# Groundwater Application Review Summary Form

Application # LL- 1856

GW Reviewer J. Hackett Date Review Completed: 03/16/2021

**SUBJECT: Scenic Waterway Interference Evaluation**

**Water-Level Measurements in Nearby Wells**

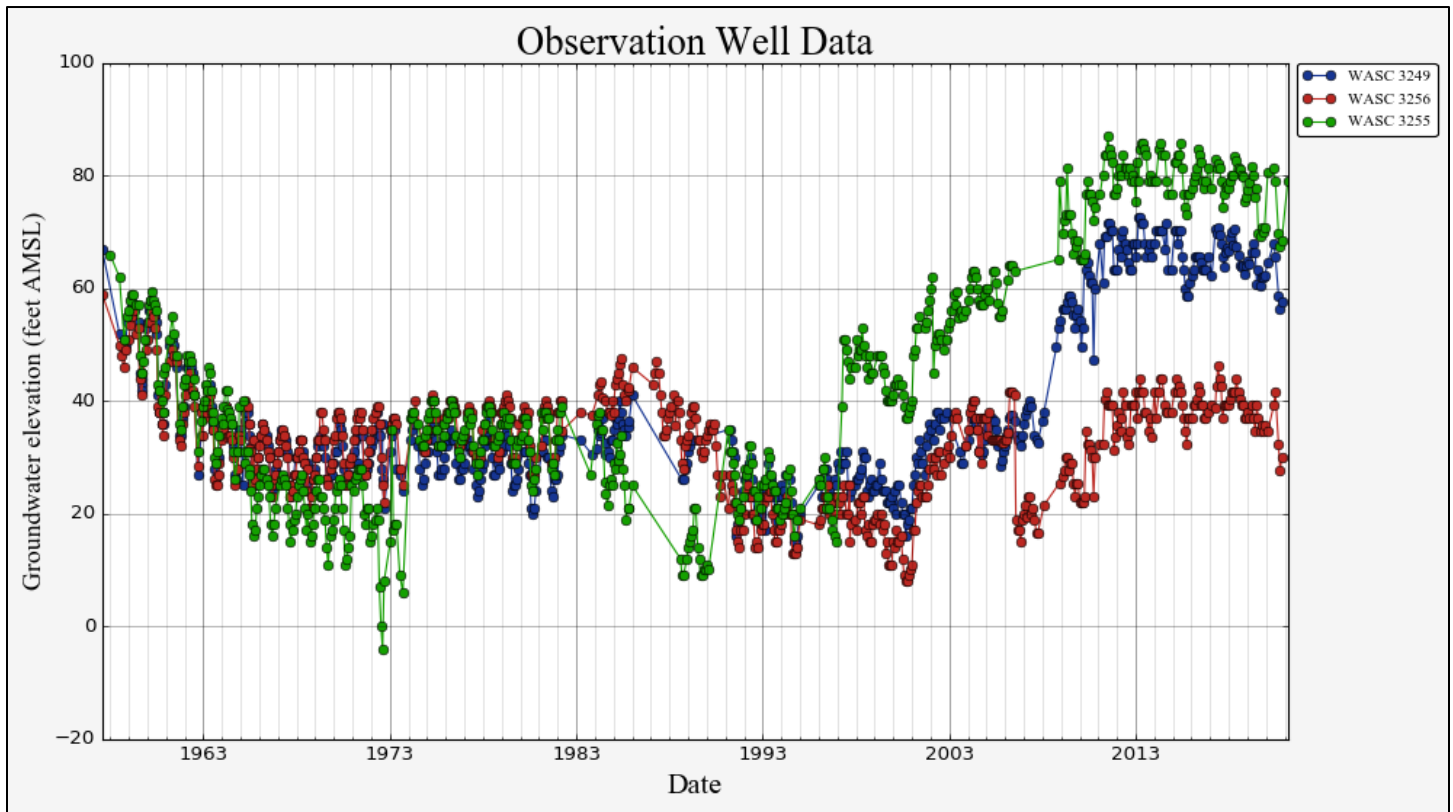
D2. **THE WELL does not appear to meet current well construction standards based upon:**

D3. **THE WELL construction deficiency or other comment is described as follows:** \_\_\_\_\_  
\_\_\_\_\_  
\_\_\_\_\_  
\_\_\_\_\_

D4.  Route to the Well Construction and Compliance Section for a review of existing well construction.
